BELL SYSTEM PRACTICES
Teletypewriter and Data Stations

SECTION P30.658
Issue 2, August, 1960
AT&TCo Standard

STATION ASSEMBLY

XRT200 AND XRT201

SA7.02 Mounting of TP106974** Panel

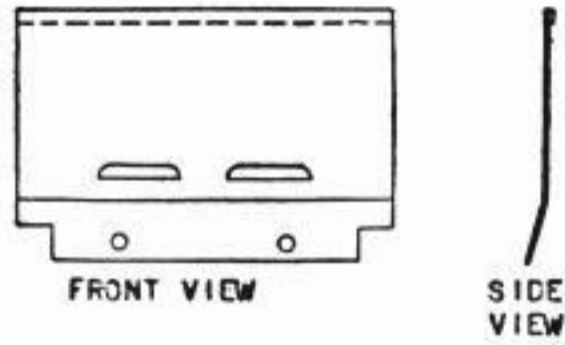
(1) "1/8" TO 1/4" CLEARANCE" has been added.

SA7.04 Mounting of TP115730 Paper Supply Box Assembly

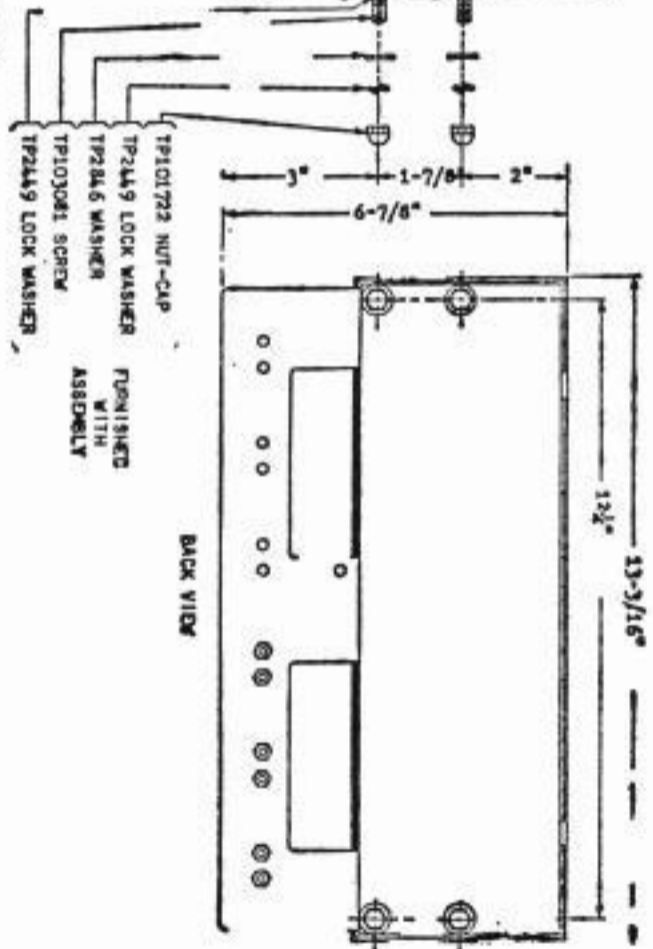
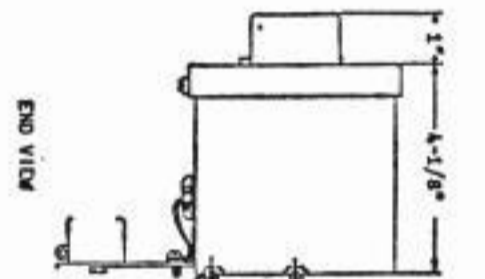
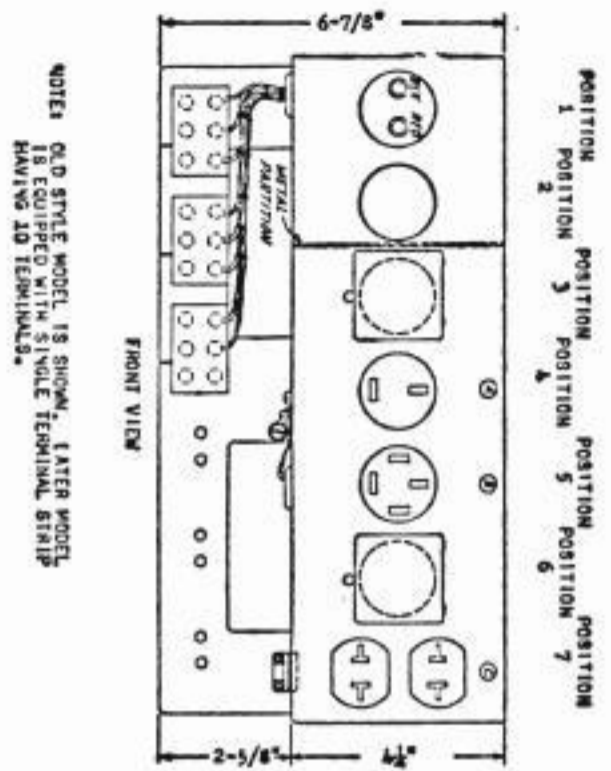
(2) ".266" DRILL (#14)" has been changed to "17/64" DRILL."

2" dimension has been added.

SA7.05 Mounting of TP117852 Electrical Service Assembly

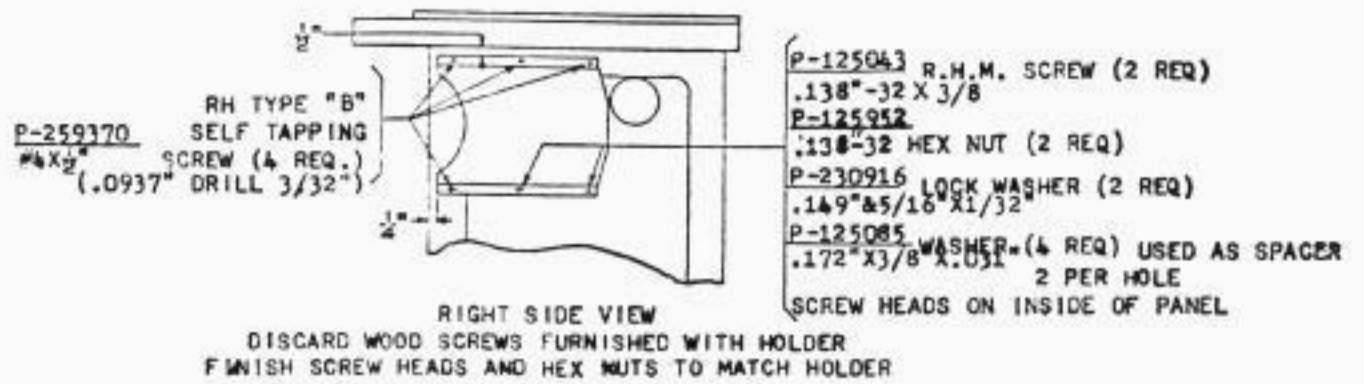
(4) "NOTE: OLD-STYLE MODEL IS SHOWN. LATER MODEL IS EQUIPPED WITH SINGLE TERMINAL STRIP HAVING 10 TERMINALS" has been added.

SA7.06 TWX Directory Holder 38Y3816

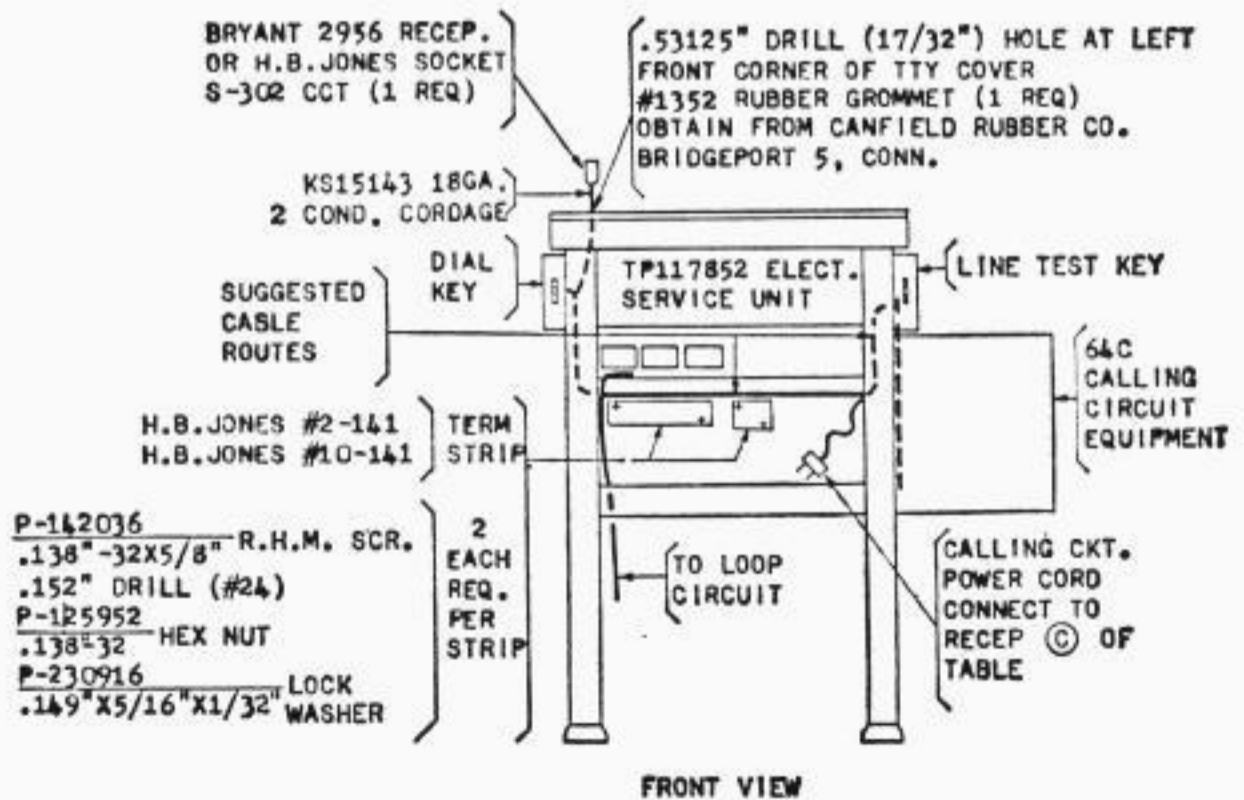
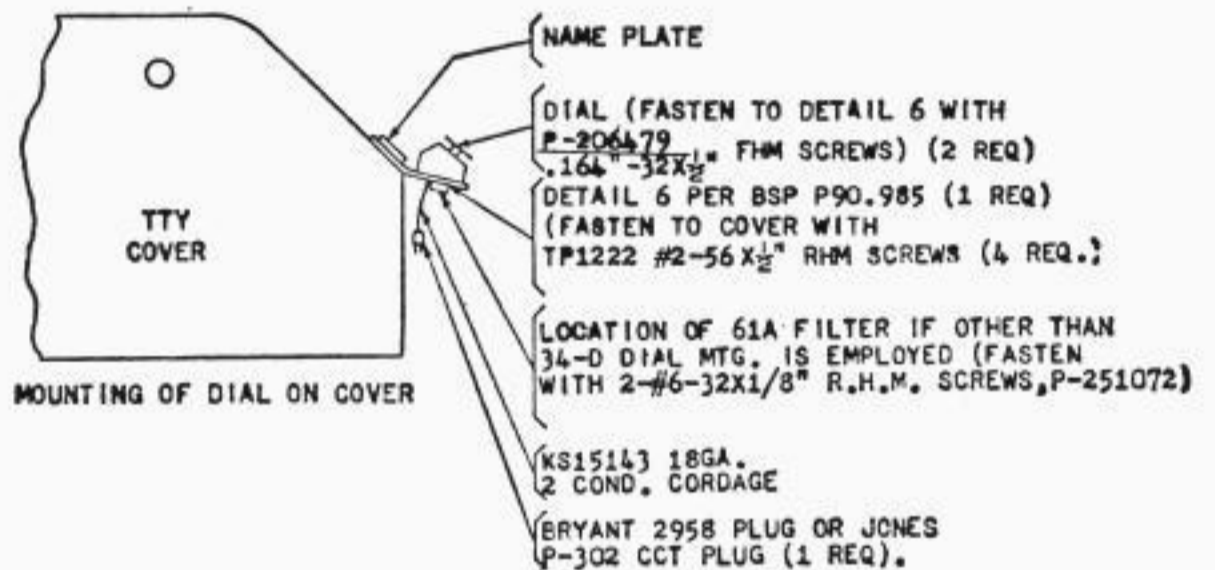
- (5) $\frac{\text{" P-125949}}{.138-32\&1/2\text{"}}$ RHM SCREW (2 REQ)" has been changed to $\frac{\text{" P-125043}}{.138\text{"}-32\times3/8\text{"}}$ SCREW (2 REQ)."
- (6) "SCREW HEADS ON INSIDE OF PANEL" has been added.
- (7) "FINISH SCREW HEADS TO MATCH HOLDER" has been changed to "FINISH SCREW HEADS AND HEX NUTS TO MATCH HOLDER."
- (8) Title "SA7.06 Instruction Book Holder 38Y3736" has been changed to "SA7.06 TWX Directory Holder 38Y3816."

SA7.07A 64C Calling Station Arrangement

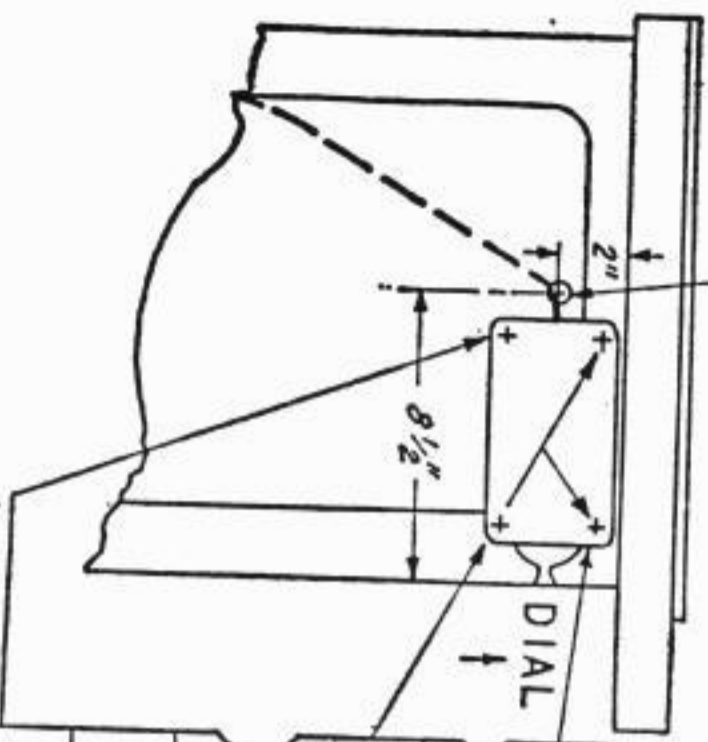
- (9) "18-2 TIREX 2 COND. LAMP CORD" has been changed to "KS-15143 18GA. 2 COND. CORDAGE."
- (10) "18-2 TIREX" has been changed to "KS-15143 18GA. 2 COND. CORDAGE."
- (11) "64C1 CALLING CIRCUIT EQUIPMENT" has been changed to "64C CALLING CIRCUIT EQUIPMENT."

SA7.07B 64C Calling Station Arrangement

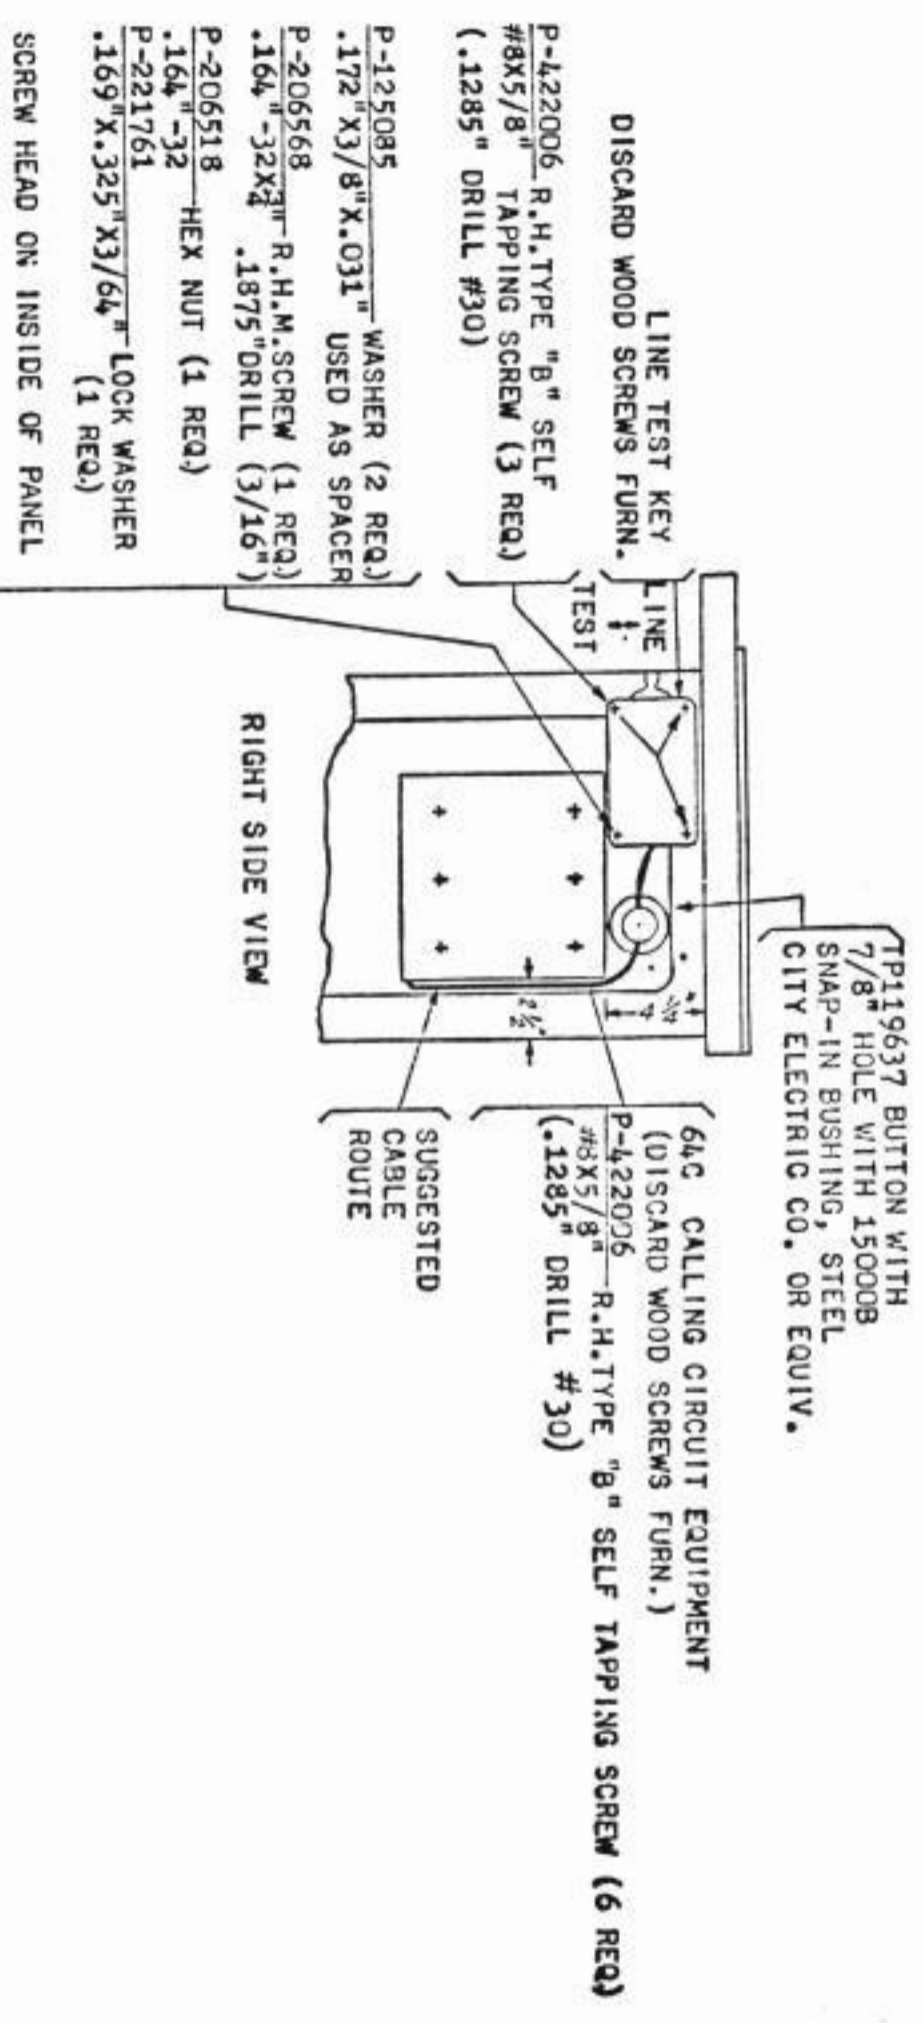
- (12) "SCREW HEAD ON INSIDE OF PANEL" has been added.

SA7.07C 64C Calling Station Arrangement

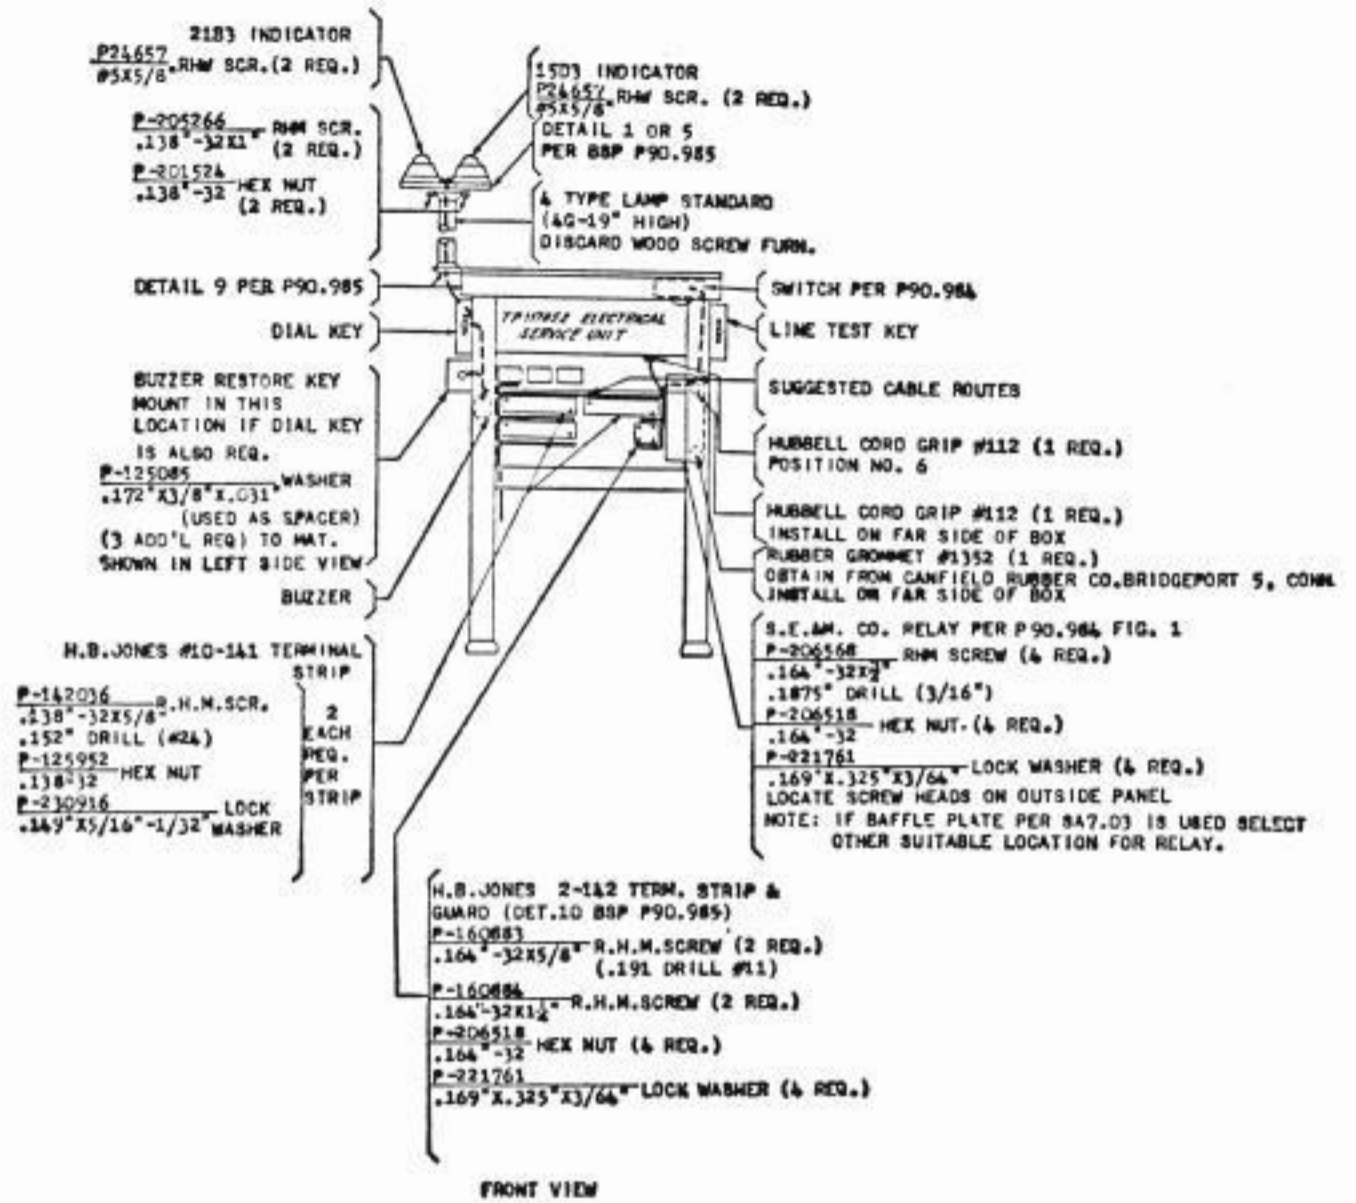
- (13) "REMOVE TP119637** BUTTON AND STORE" has been changed to "TP119637 BUTTON WITH 7/8" HOLE WITH 15000B SNAP-IN BUSHING, STEEL CITY ELECTRIC CO., OR EQUIV."
- (14) $\frac{\text{"P-405652}}{\#8\times5/8\text{"}}$ RH TYPE "Z" SELF TAPPING SCREW (6 REQ)" has been changed to $\frac{\text{"P-422006}}{\#8\times5/8\text{"}}$ RH TYPE "B" SELF TAPPING SCREW (6 REQ)."
- (15) "SCREW HEAD ON INSIDE OF PANEL" has been added.
- (16) "64C1 CALLING CIRCUIT EQUIPMENT" has been changed to "64C CALLING CIRCUIT EQUIPMENT."

SA7.08D 64C Receiving Station Arrangement

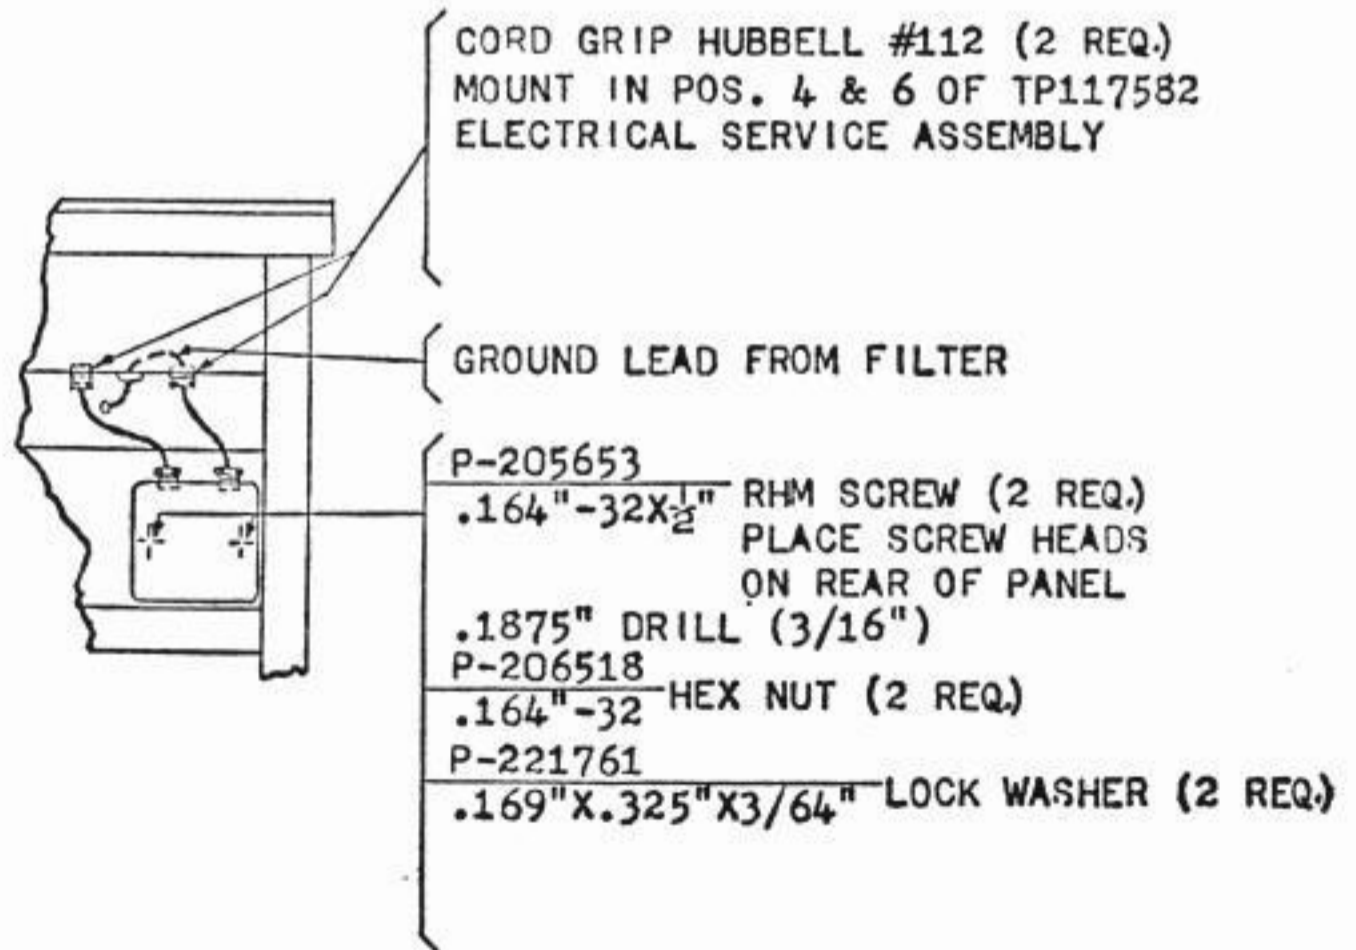
- (17) "REMOVE TP119637** BUTTON AND STORE" has been changed to "TP119637 BUTTON WITH 7/8" HOLE WITH 15000B SNAP-IN BUSHING, STEEL CITY ELECTRIC CO., OR EQUIV."
(18) "SCREW HEAD ON INSIDE OF PANEL" has been added.

SA7.10 150A1, 150B1, or 150C1 Wave Shaping Set

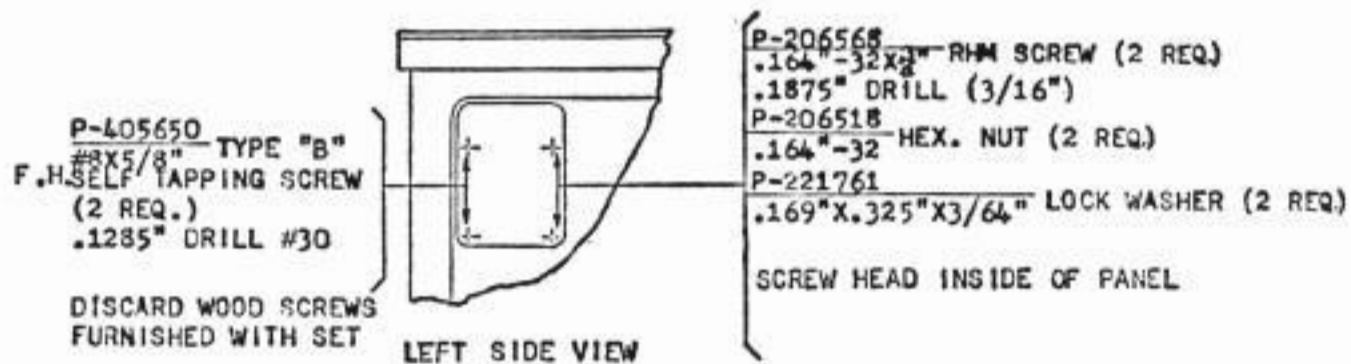
- (19) "P-405647
#8x1" TYPE "Z" SELF TAPPING SCREW
(3 REQ)" has been changed to "P-422008
#8x1" TYPE
"B" SELF TAPPING SCREW (3 REQ)."
(20) "RIGHT SIDE VIEW" has been changed to
"LEFT SIDE VIEW."
(21) "SCREW HEAD INSIDE OF PANEL" has been
added.

SA7.11 150D1, 150E1, or 150F1 Wave Shaping Set

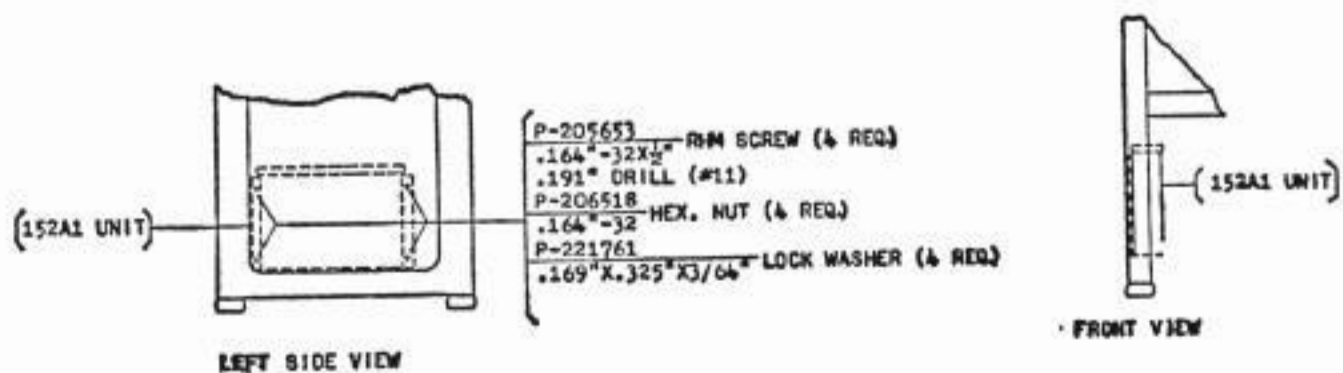
- (22) "RIGHT SIDE VIEW" has been changed to
"LEFT SIDE VIEW."
(23) "SCREW HEAD INSIDE OF PANEL" has been
added.
